FINAL PRODUCT/PROCESS CHANGE NOTIFICATION #16587Generic Copy

Issue Date: 07-Mar-2011

TITLE: Qualification of Nantong Fujitsu Microelectronics Co.,Ltd. for Assembly/Test of D2PAK (TO-263) Bipolar Power Transistors, Power Schottky and Ultrafast Rectifiers.

CHANGED PART IDENTIFICATION:

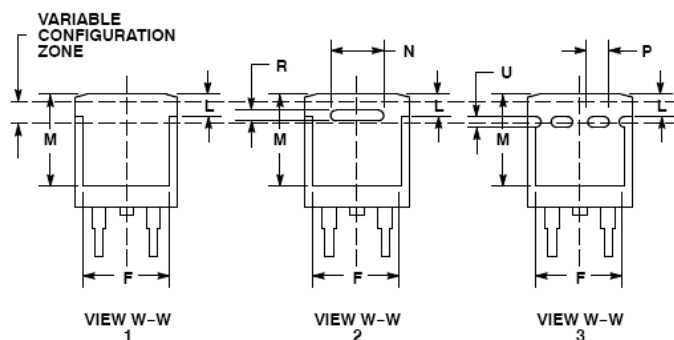
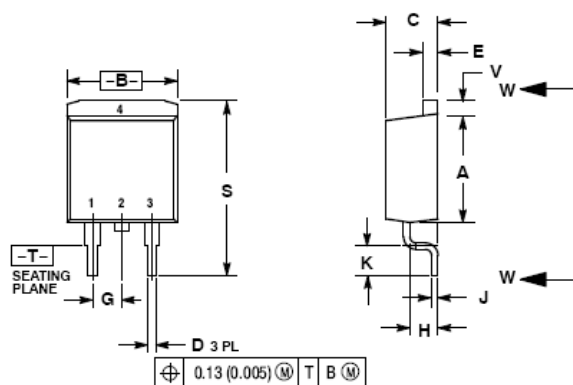
Product from Nantong Fujitsu will be identified by NF site code marking.
